Preservation Department – Item 1, LPC-22-08731

**6301 12th Avenue, aka 6301-6323 12th Avenue, 1202-1216 63rd
Street, and 1201-1215 64th Street – Angel Guardian Home –
Individual Landmark
Borough of Brooklyn**

LPC-22-08731: 6301 12th Avenue, Angel Guardian Home - Individual Landmark

PUBLIC MEETING SCOPE 09/20/2022

CHANGES:
 • NEW MECHANICAL LOUVRE

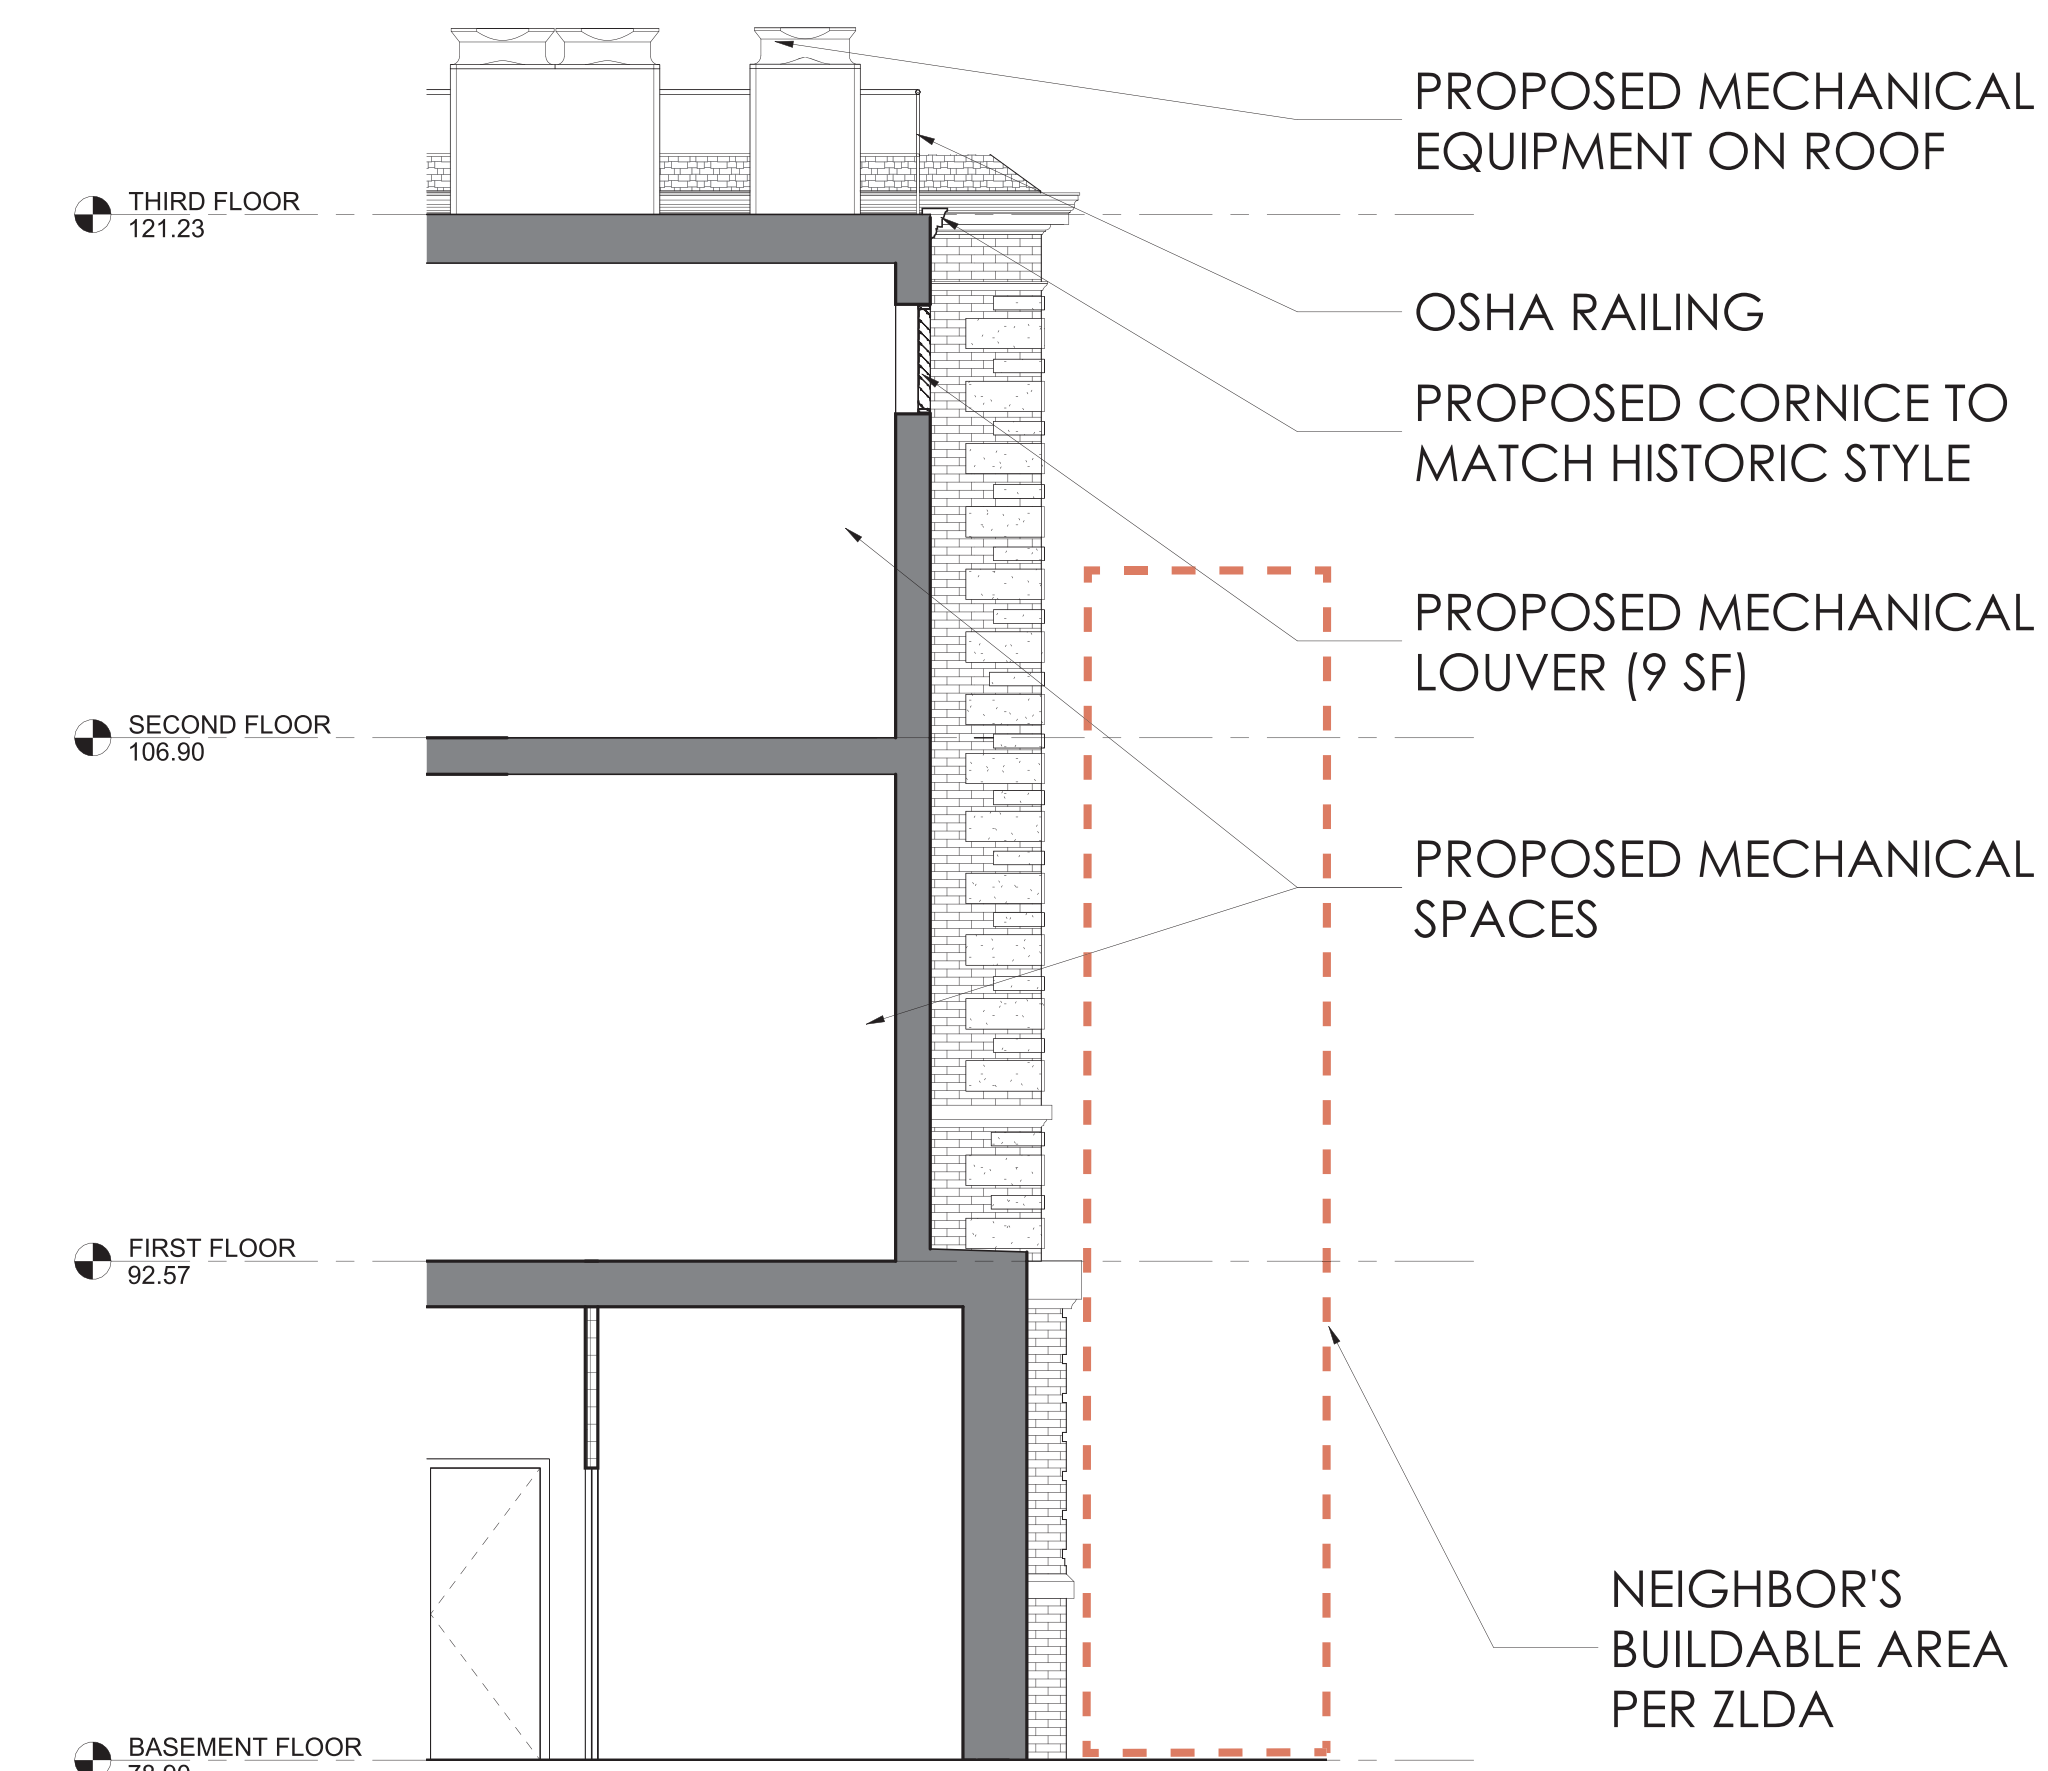
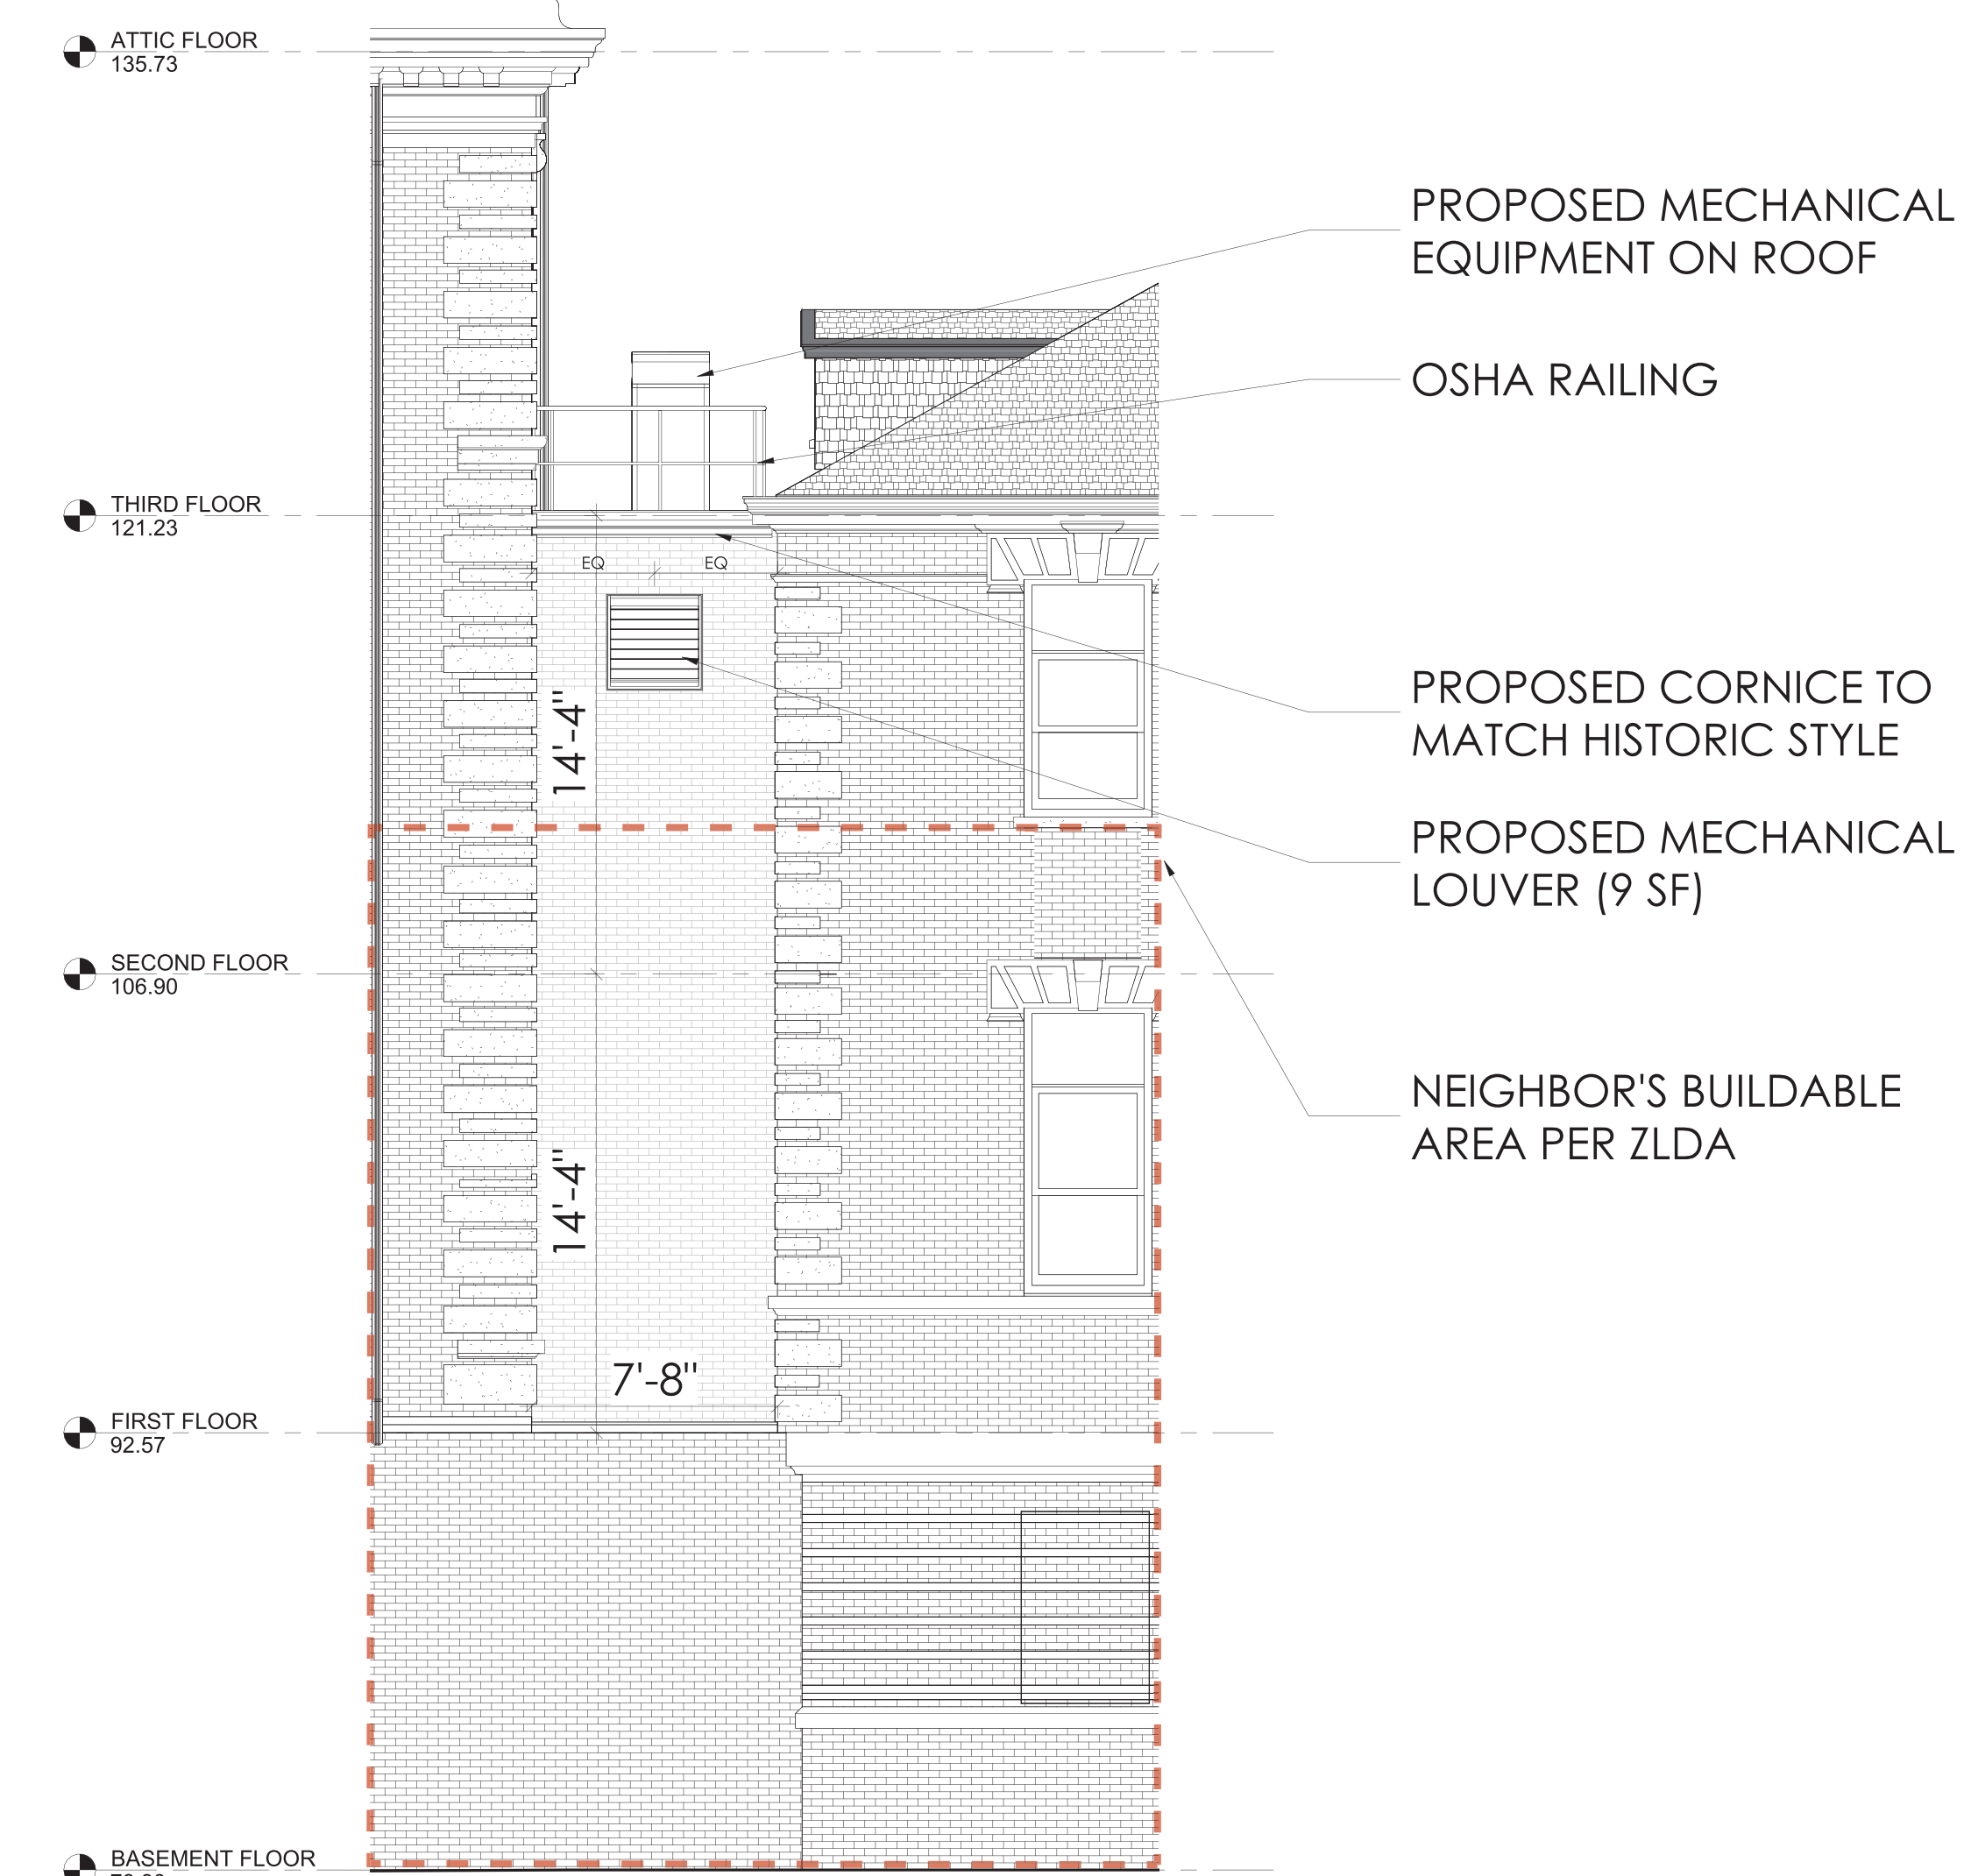
- CHANGES:
- NEW MECHANICAL LOUVRE
 - ELEVATOR BULKHEAD HEIGHT
 - DOWNSPOUTS MATCH COPPER
 - ADDITIONAL REAR FACADE LIGHT FIXTURES
 - REAR FACADE SECURITY CAMERA FIXTURE
